Application for "Other Business"
Cobb County, Georgia

OB-022-2016

State specifically the need or reason(s) for Other Business: To reduce 30 foot undisturbed buffer area in the rear of my property at 4260 Thayer DR, Lot 11. This is per O.B. 30, 08-18-2015 BOC hearing

State specifically the need or reason(s) for Other Business: To Change the 30 foot buffer to a 10 foot buffer in the rear of 4220 Thayer Drive (Lot 7) in an agreement with OB38 08/18/15

Min. Bk. ____ Petition No. ____
Doc. Type Site Plan
Meeting Date May 18, 2004

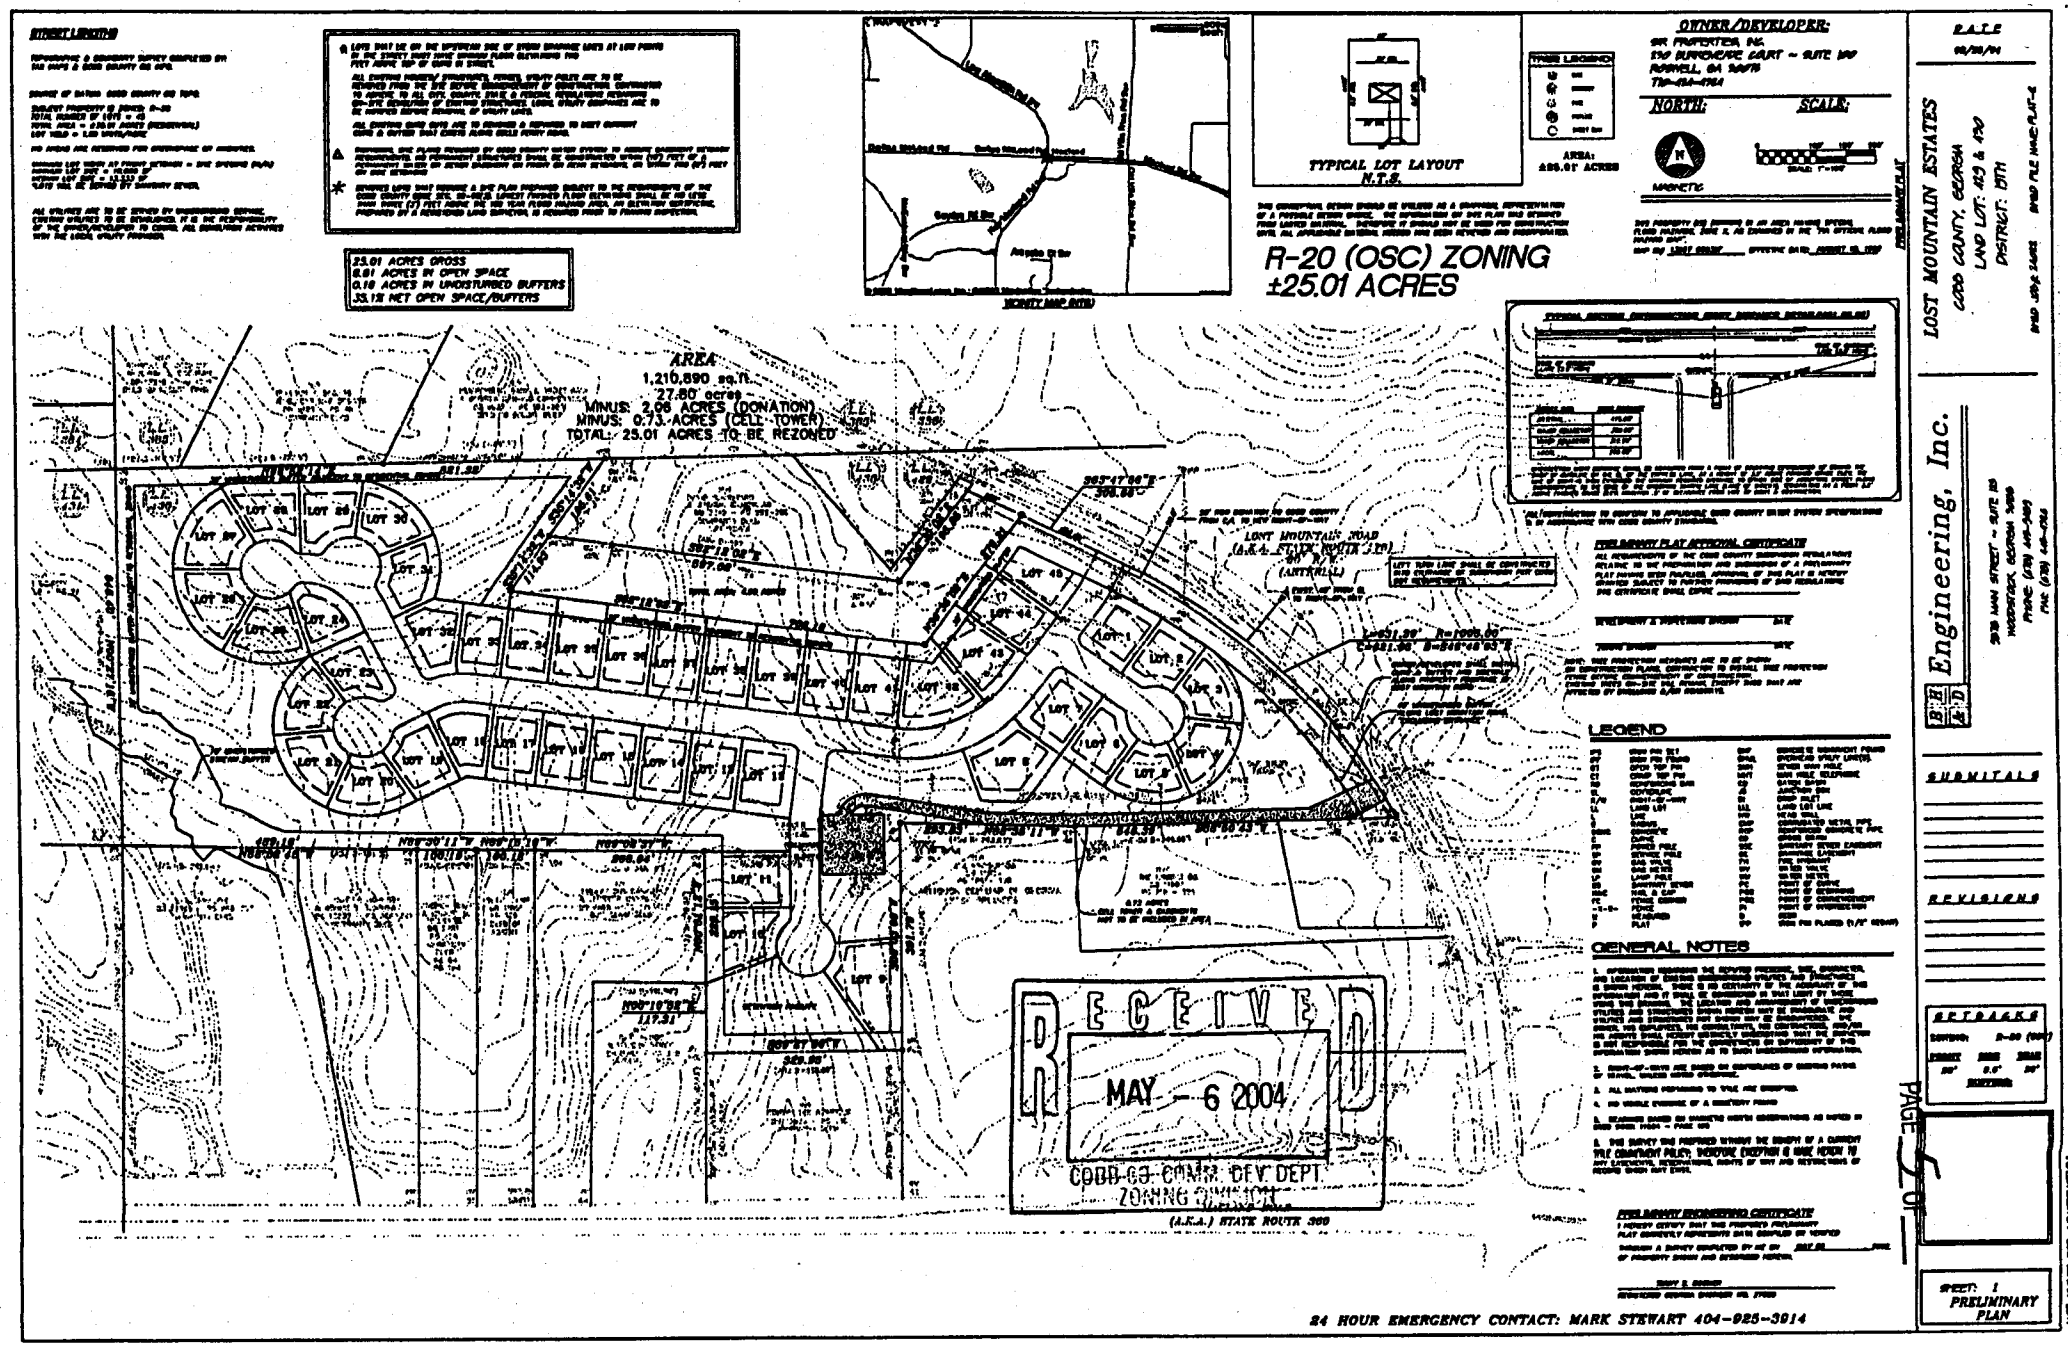
Revised Plan 3-30-04 to Zoning
Revisions appear to be addition of undisturbed buffer 30-40 feet wide around outer perimeter adjacent to residential property and addition of note defining statistics of open space. Note is taken of said undisturbed buffer being superimposed upon residential building lots. With each owner endeavoring to create that unique landscaping on the lot the chance of the undisturbed buffer character remaining is slim. Suggest all building lots be removed from the buffer and placed totally in the community open space.

This writing appears to ignore concerns of Stormwater Management relative to amount of grading required (and the pollution potential there from) plus, the layout not flowing with terrain (lots being placed on wooded steep slopes while vast expanses of cleared flatter land is left open) plus, special needs to protect downstream lakes, plus, inadequate detention proposed. The objective of Open Space Community is to allow for more concentrated development on the more useable areas of the site, and leave the less useable areas unused-open space. The proposed plan does not accomplish that goal. As "Open Space Community" was created to protect critical areas and any approval will be "to a plan" we submit this plan as not ready for approval.

To reiterate, Lots 30-36 need to be moved from the much steeper wooded slopes behind the shopping center detention facility and loading docks to the flatter open area in southeast corner. Lots 20-23 need to be moved from the steeper wooded slopes to the flatter open area in the northwest corner. Site detention can be easily fitted into the established ravines without major change if the lots are so relocated. In this way grading requirements can be reduced and sediment / pollution loss potential can be diminished and the downstream lakes can be better protected.

This revised plan does redistribute lots utilizing more of the flatter terrain per previous Stormwater Management requests but:

(1) Still does not provide stormwater controls for the western section which naturally flows away from the proposed detention;
(2) Several lots remain on very steep slopes;
(3) The natural ravine of Lots 10, 11 is not utilized for detention, which has been sited on an elevated hillside requiring massive grading.

(4) Latitude be granted to Stormwater Management staff, to work with plan and developer, to insure adequate Stormwater / Water Quality protection for downstream Lakes.
(5) For any lot with greater than 15% natural grade in building area and for any lot intended to be mass graded to a level (+/-) plateau, request an individual site plan be submitted to Stormwater Management for review.
(6) Detention be relocated to take full advantage of the natural ravine in the southern panhandle to minimize grading and the pollution potential higher level grading will generate.
(7) Negotiations be entered into with cell tower easement owner to make certain adjustments that would allow Lots 9-11 to be located between Lot 8 and Lot 12 on the main road. This would reduce the road work and lot grading amount and thereby reduce pollution potential of downstream lakes.

Stormwater Management still has concerns about the ability to accurately predict a specific number of lots given the steep terrain and future lot grading which is unknown at this time. Fifteen (15) lots and 3 cul-de-sacs in the west still drain away from detention as shown. This area must be adjusted by addition of detention / Water Quality-Best Management Practice or mass graded to redirect runoff and thereby increase the pollution potential. A significant area of offsite drainage is naturally concentrated into Lot 38, which will require very special design at Plan Review. The 30-foot undisturbed buffer

lying on Lot 34-45 will be difficult at best to enforce in the face of each property owner working to use all of each lot to create that uniquely landscaped yard desired.
